**MANOR PLANNING & ZONING
COMMISSION MEETING
AGENDA
105 E. EGGLESTON STREET
MANOR, TEXAS 78653
JULY 13, 2016 • 6:30 P.M.**

Re: Stonewater North Subdivision
Fourth Preliminary Plan Application Submittal
City of Manor

Re: Stonewater North Subdivision
Fourth Preliminary Plan Submittal Review
City of Manor

SHEET NUMBER
2

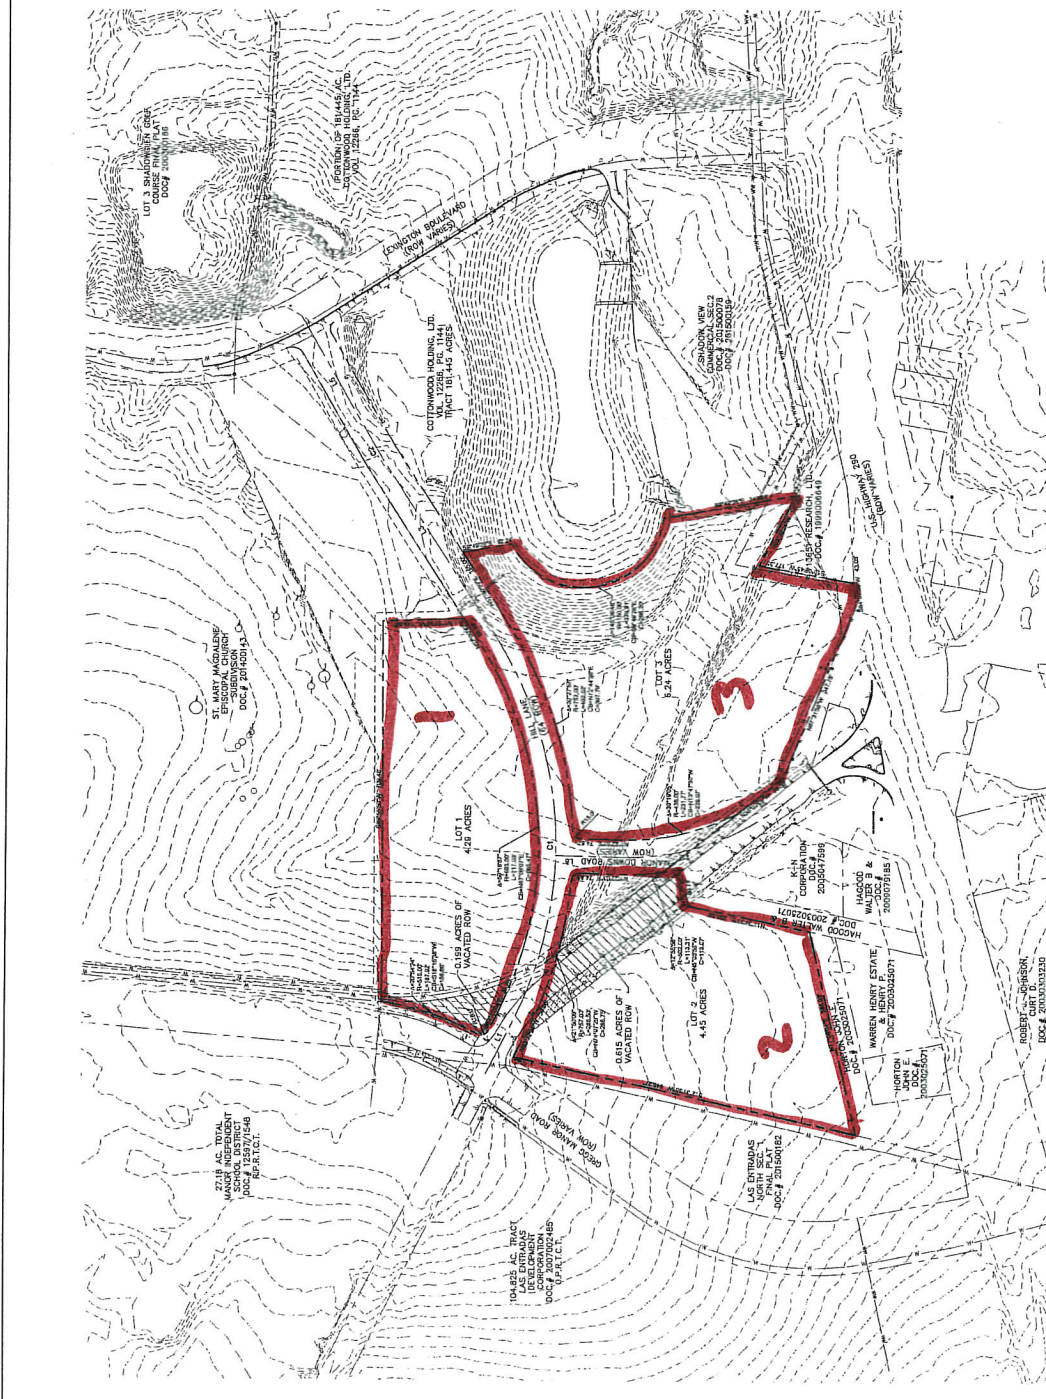
1. The proposed Preliminary Plan includes lots that were not previously included within a concept plan. A concept plan for the proposed development needs to be approved. The Concept Plan was submitted to our office and will be reviewed.
2. The cover should read "Preliminary Plan Only – Not for Recordation."
3. Copies of the mailing labels for property owners within three hundred feet of the subdivision was not provided. Mailing labels were not provided to the City of Manor.
4. Elevations should be labeled on all topography.
5. On Sheet 3 the size of the existing sewer line located along Lexington Boulevard should be labeled.
6. It should be verified that no significant trees are located within the proposed development. If there are significant trees,
